## ADDENDUM NO. 5

Project: Nunavut Water Board New Office Building  
Location: Gjoa Haven, NU  
Project no: RFP GH 2018-001 TAG:17-017  
Date: March 6<sup>th</sup>, 2018

BID DOCUMENTS FOR  
NUNAVUT WATER BOARD OFFICE BUILDING

E200

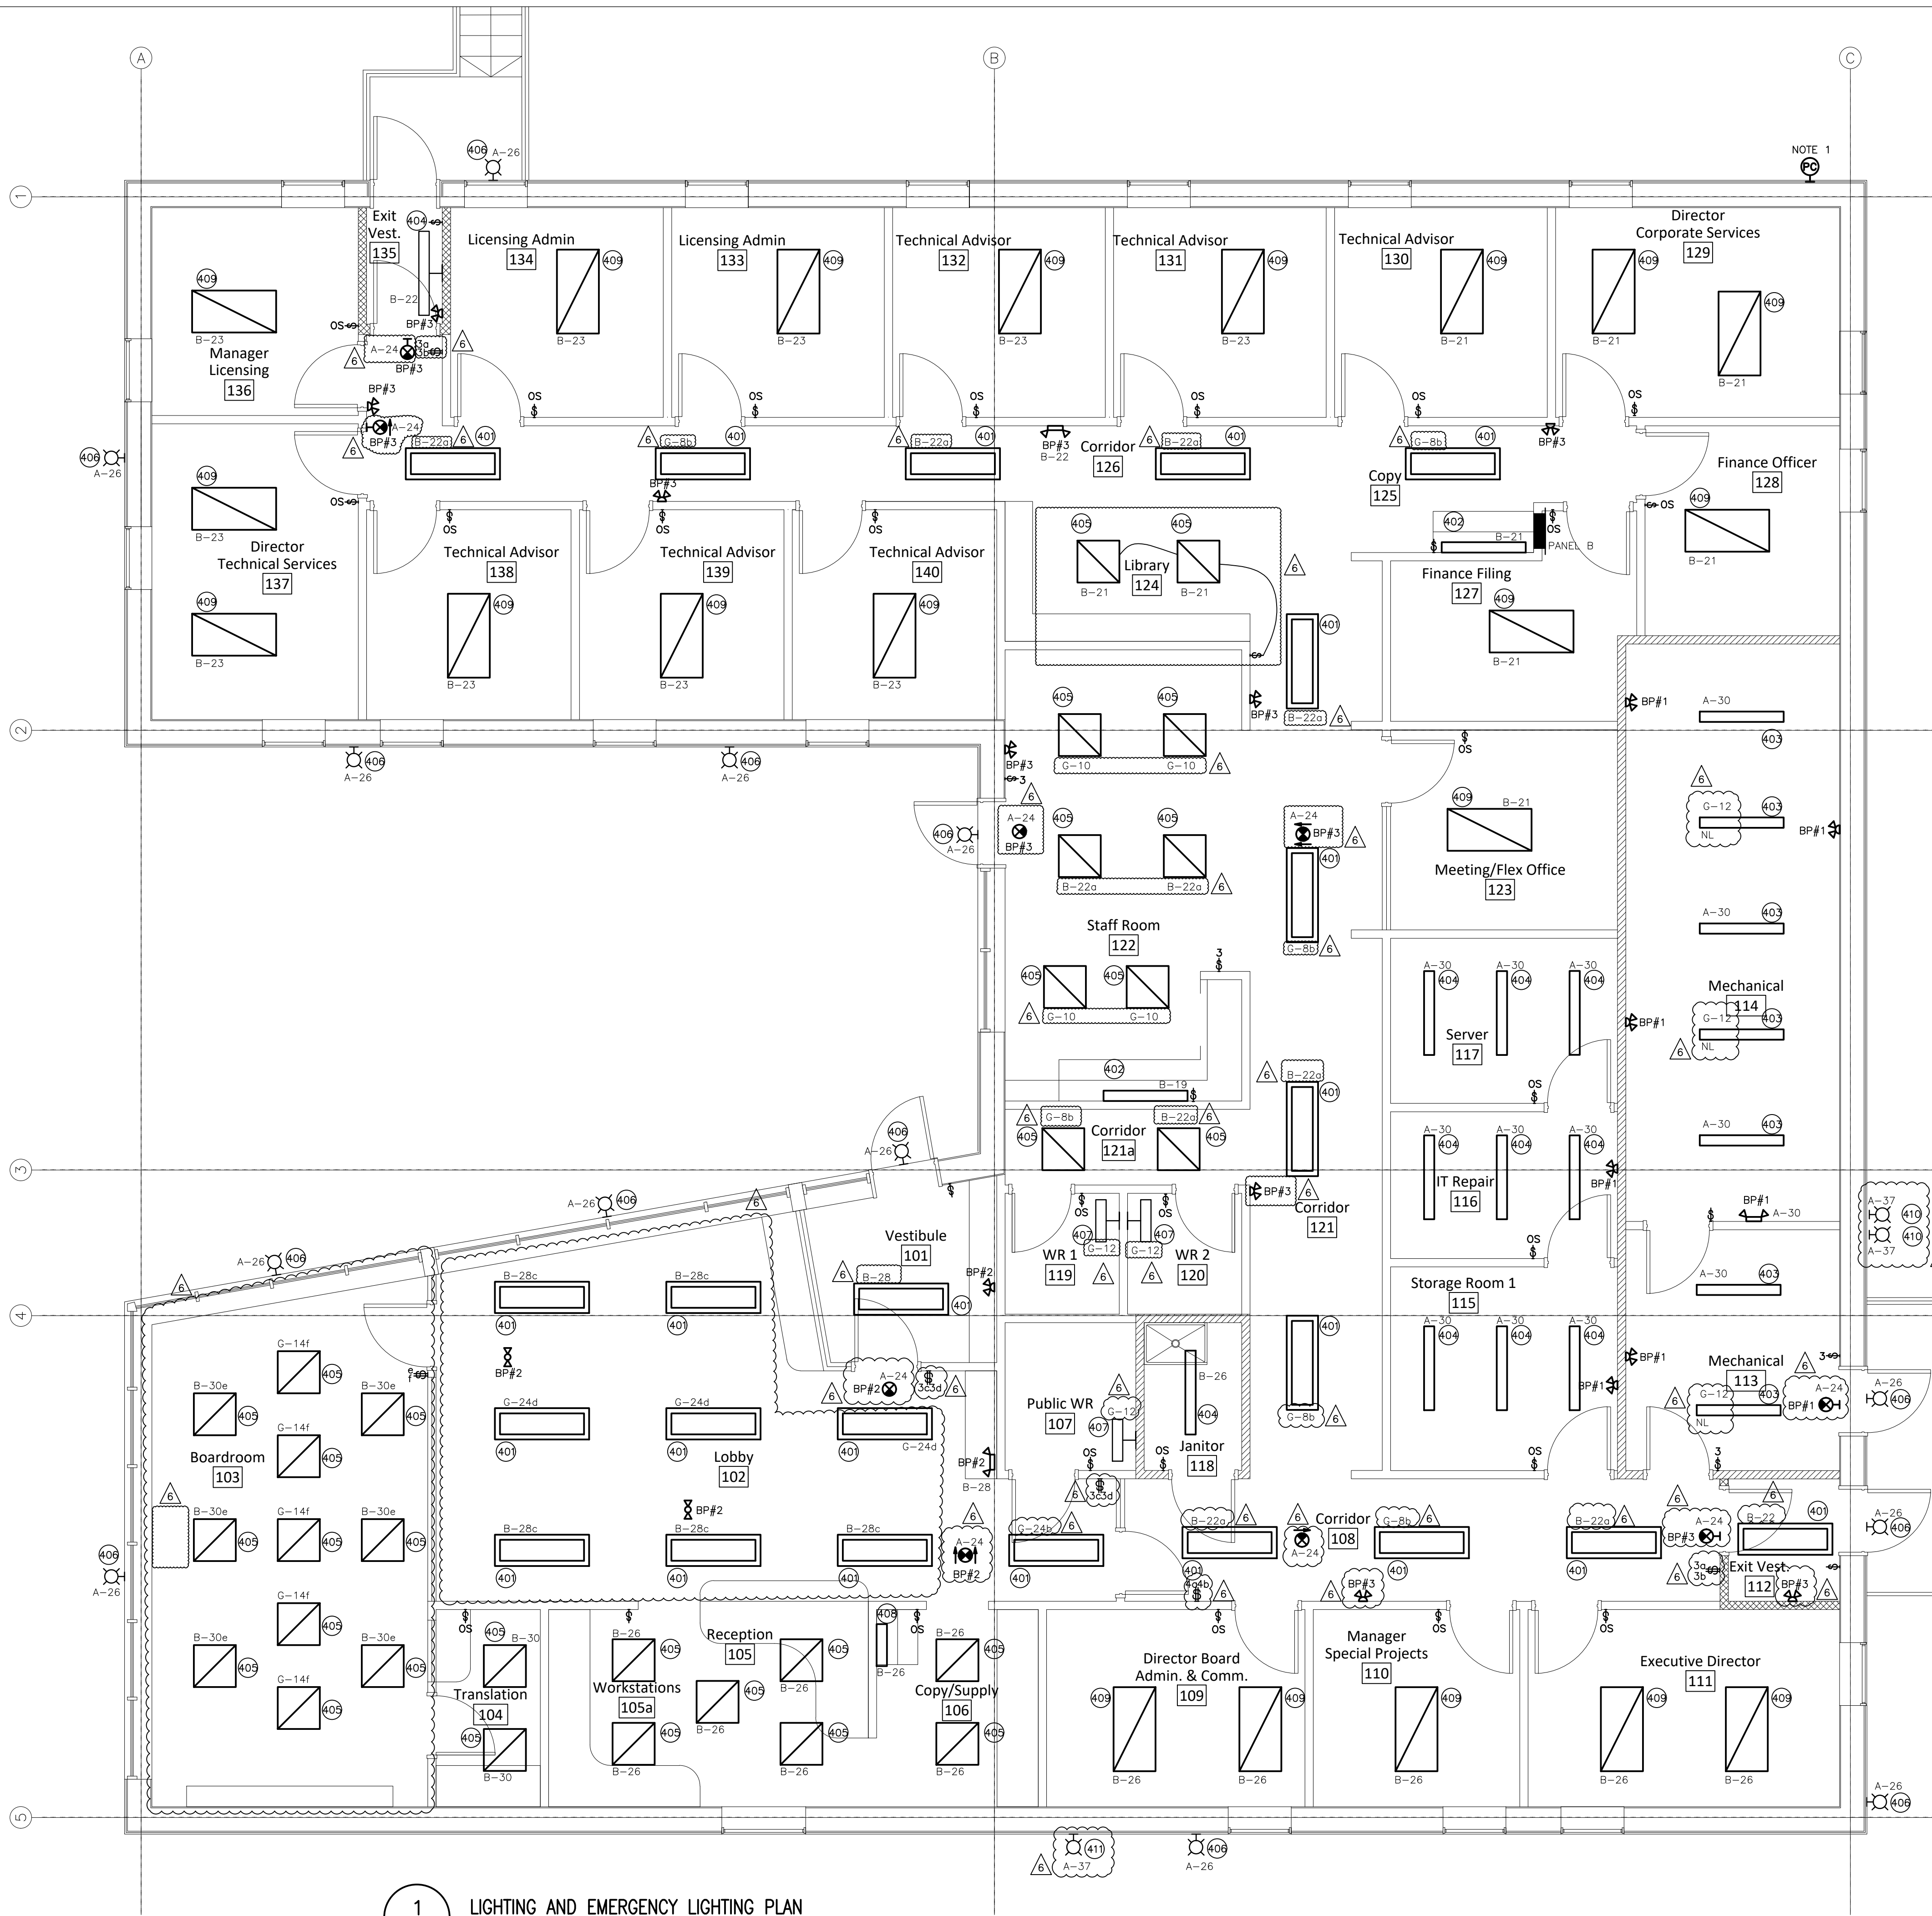
1. Clarifications
  - 1.1. Refer to electrical drawings E200, E201, E202, and E500 for clarifications. Clarifications are clouded and marked with revision #6.

- 3.1.1. *Question:* Can we use self-powered Universal Exit Lights instead of bringing a DC Circuit into each exit fixture?
    - 3.1.2. *Response:* No; exit signs to be circuited to common AC circuit and powered via DC circuits to battery packs. Refer to drawing E200 & E500. This has now been clarified on the drawings and in panel schedule for Panel A.

1 LIGHTING AND EMERGENCY LIGHTING PLAN  
E200 1:50

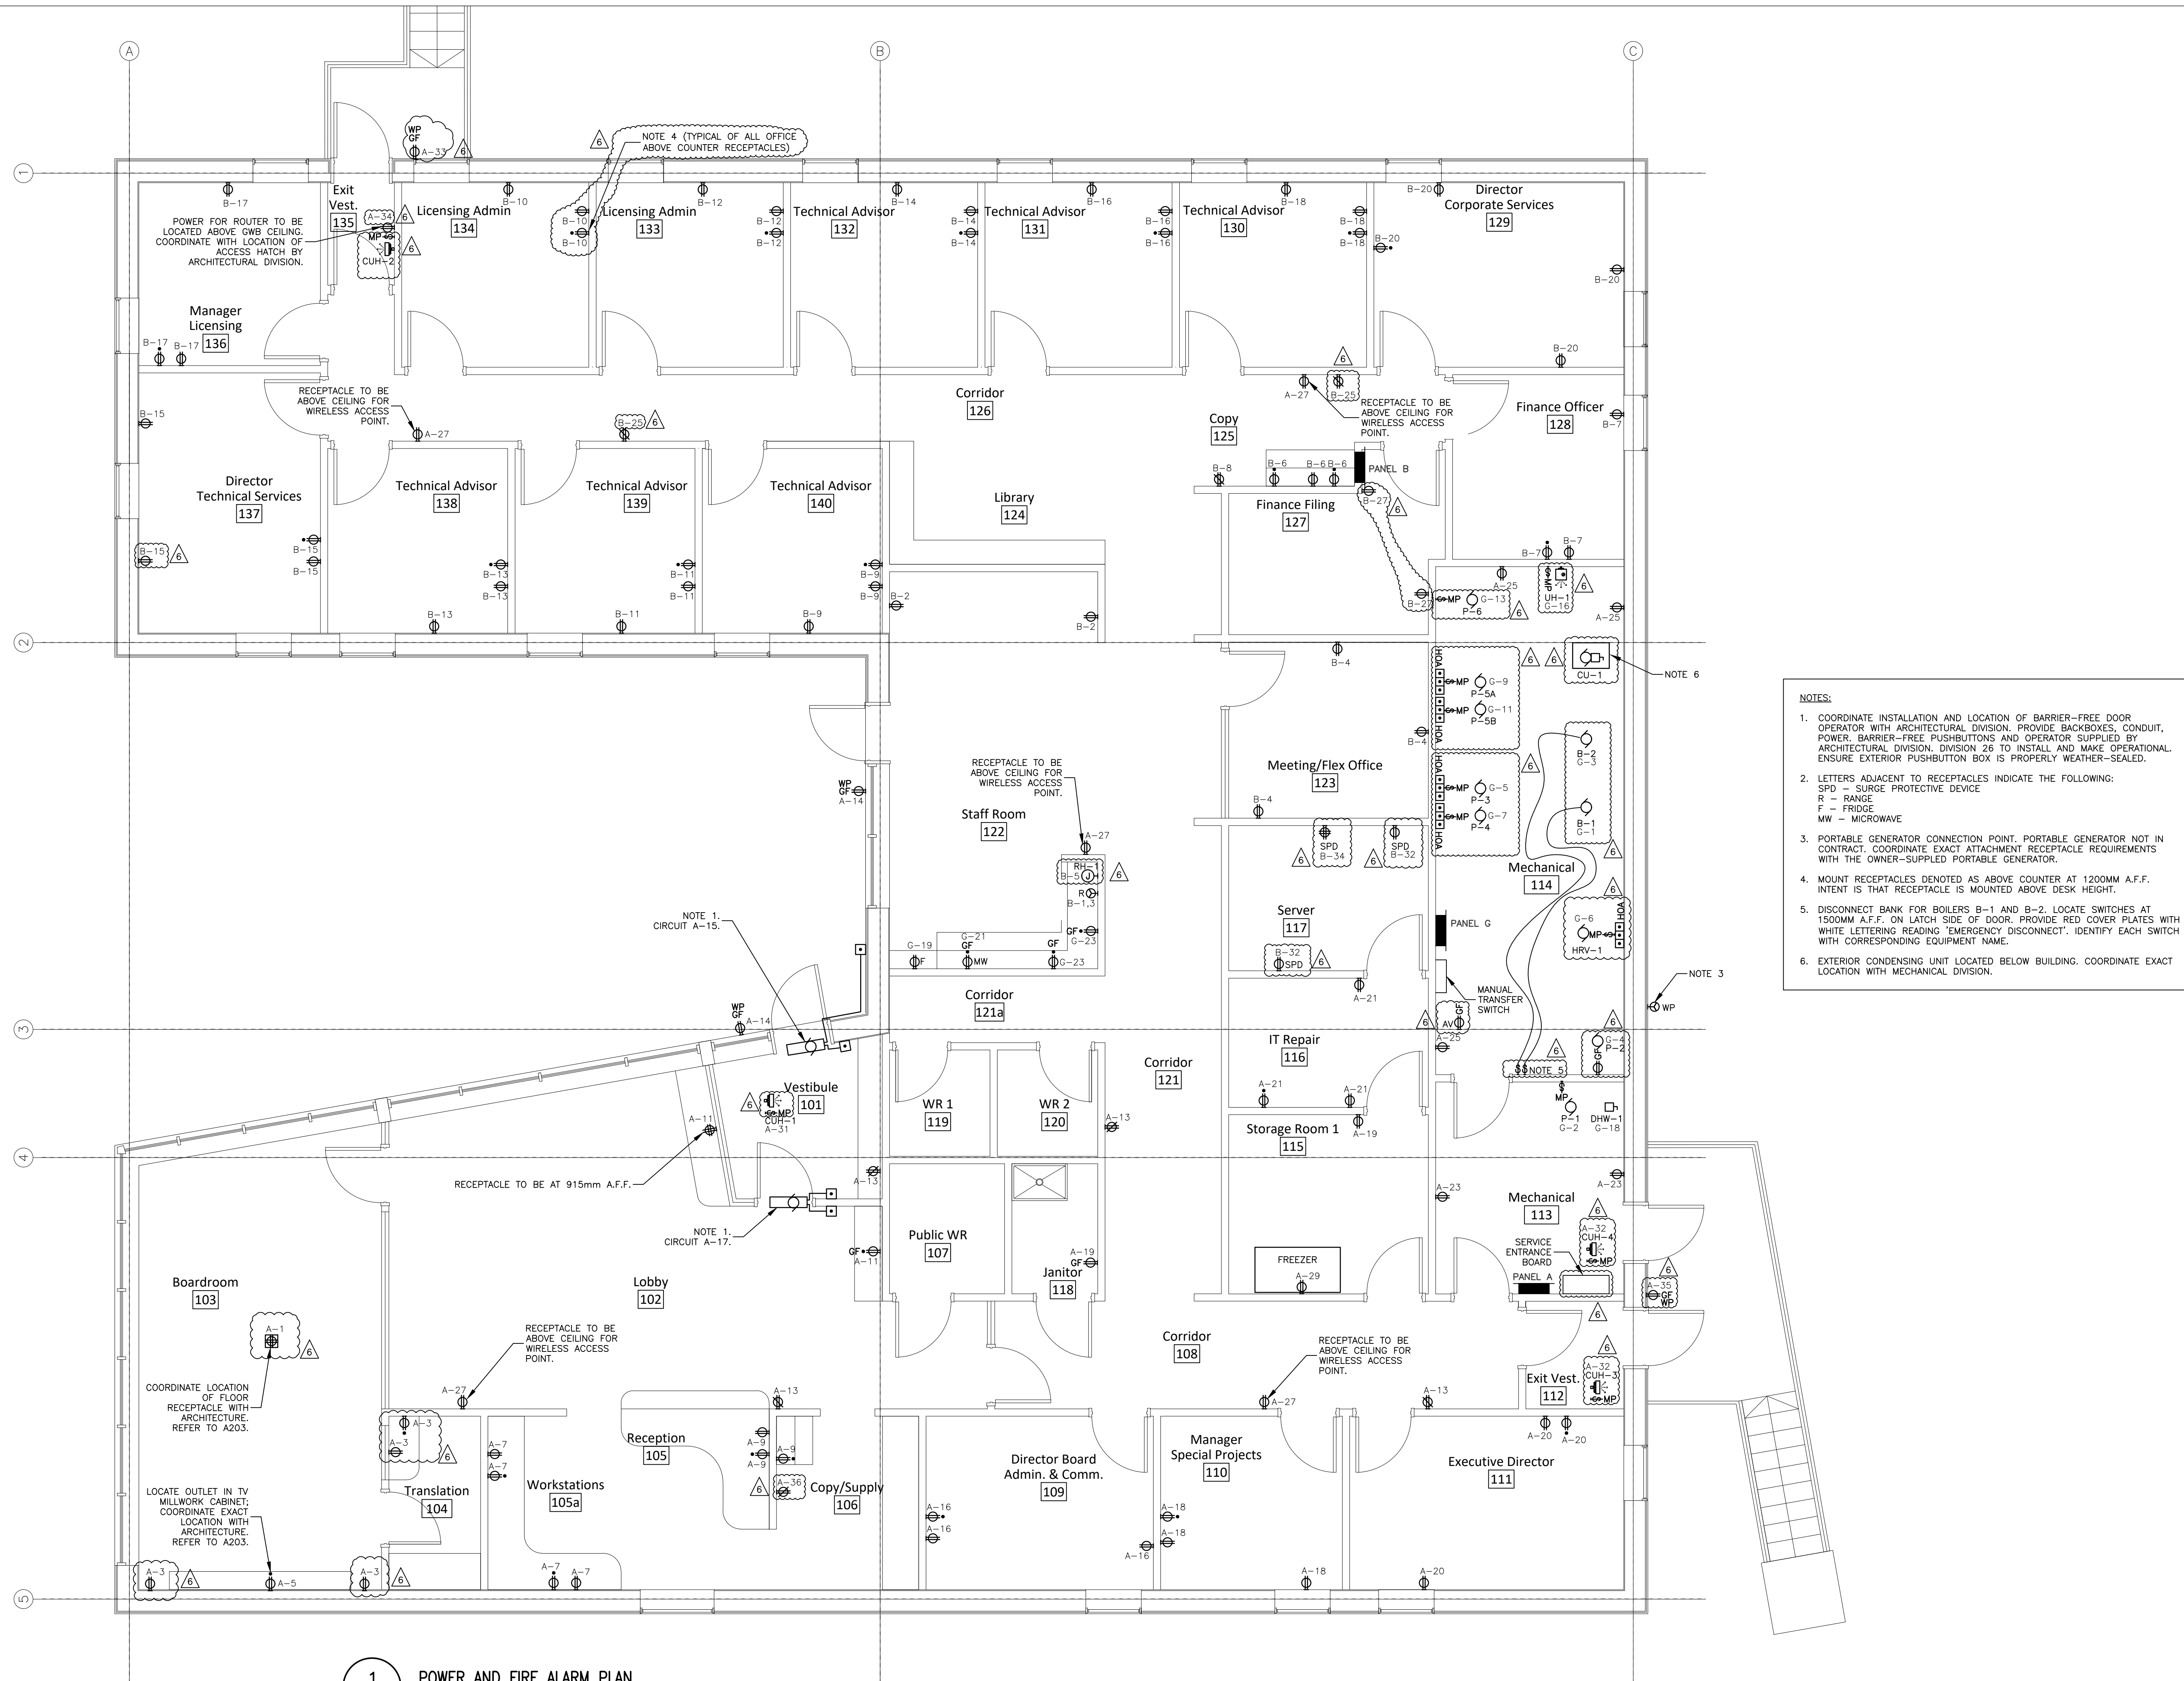
- 3.2. Question from bidder re: light switching:
    - 3.2.1. *Question:* Can you confirm the intent for switching in this building.
      - 3.2.1.1. Is the Intention of the 3-way switching as per drawing below? (see below)

- 3.2.1.2. In Staff Room 122 there is (2) 3-way switches with (2) lighting circuits is the plan to install a contactor to switch these lighting circuits?

- 3.2.1.3. In Corridor 126/121/108 there is (3) 3-way switches with (4) Lighting Circuits.
        - 3.2.1.3.1. Is one supposed to be a 4-way?
        - 3.2.1.3.2. Are we to install a contactor to switch these lighting circuits?

- 3.2.1.3.3. In Lobby 102 there is (2) 3-way switches with (2) lighting circuits is the plan to install a contactor to switch these lighting circuits?

## 1 SINGLE LINE DIAGRAM

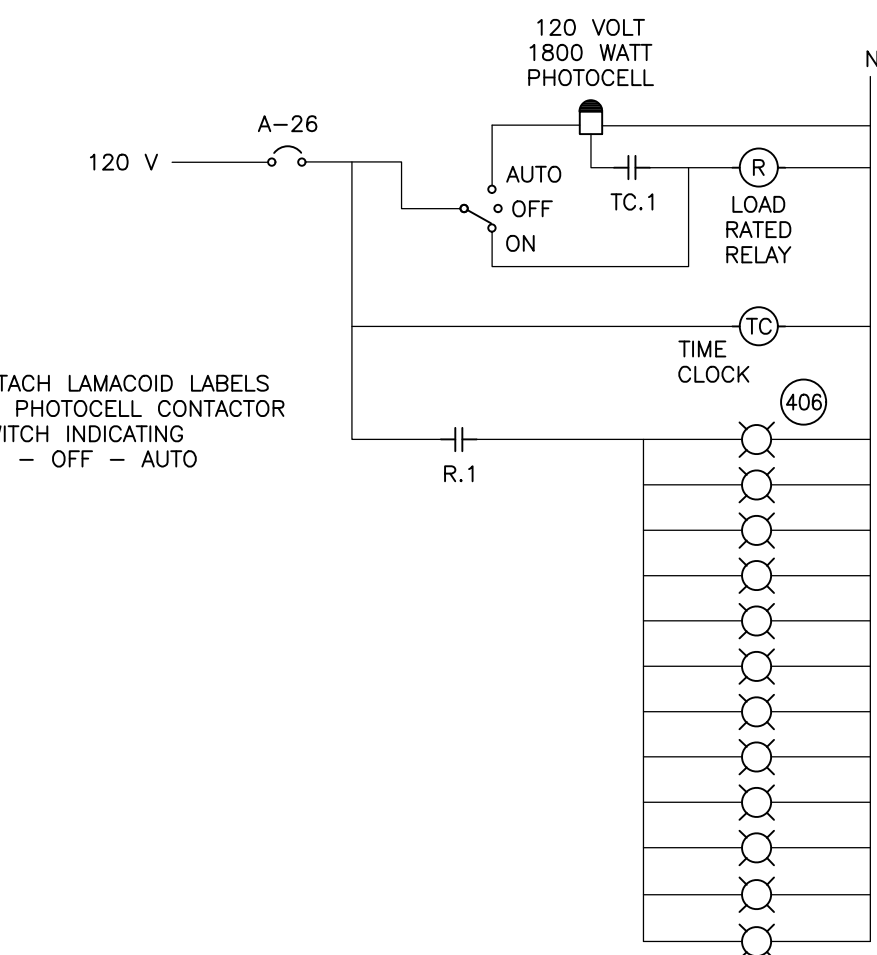
- 1.1. Refer to electrical drawing E500. Revise Panel 'G' to a 120/240V panelboard as the Owner-supplied portable generator is only capable of 120/240V power supply. Loads and equipment to remain as indicated in the schedule. Circuiting to be adjusted and reflected on as-builts (Phases A and B).
